## United States Patent and Trademark Office

APPLICATION NO.	FILING DATE	FIRST NAMED INVENTOR	ATTORNEY DOCKET NO.	CONFIRMATION NO.
09/773,036	01/31/2001	Joseph M. Probst	04645.0558	5492
7:	590 11/01/2002			
David L. Prin		EXAMINER		
Hodgson Russ One M&T Plaz	a, Suite 2000	CANTELMO, GREGG		
Buffalo, NY 14203-2391			ART UNIT	PAPER NUMBER
			1745	7
			DATE MAILED: 11/01/2002

### **DETAILED ACTION**

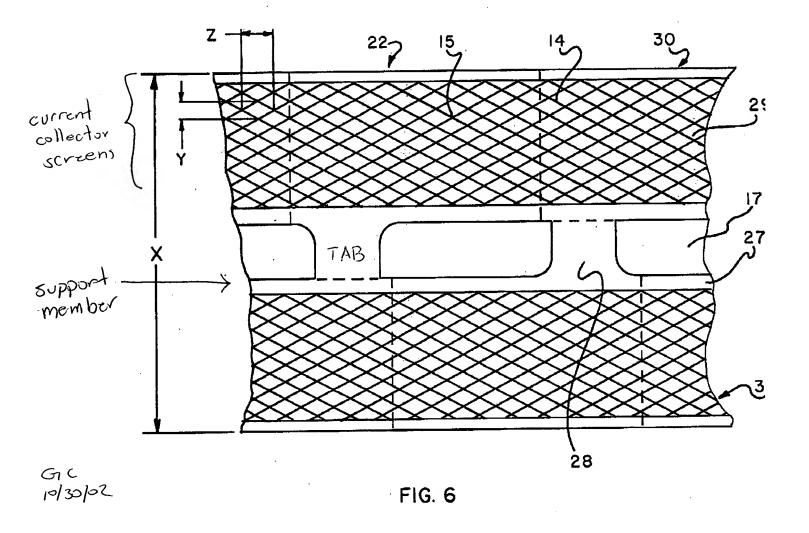
McDowell discloses a common carrier comprising: an elongate support member having a plurality of locating holes 17 disposed thereon, a plurality of current collector screens 29 integrally formed with and extending from a portion of the central support member 30 (Fig. 6 as applied to claim 1). See marked-up Fig. 6 below.

The current collector screens 29 are connected to the central support member through respective external tabs 28 extending from the current collector screen (Fig. 1 as applied to claim 2).

Loewen discloses a common carrier comprising: an elongate planar central support member having at least one datum (holes 17), a plurality of current collector screens 29 integrally formed with and extending from a portion of the central support member (Fig. 1 as applied to claim 5). See marked-up Fig. 6 below.

The current collector screens 29 are connected to the central support member through respective external tabs 28 (Fig. 1 as applied to claim 6).

The external tab 28 connects at a substantially perpendicular orientation with the central support member (Fig. 1 as applied to claim 7).
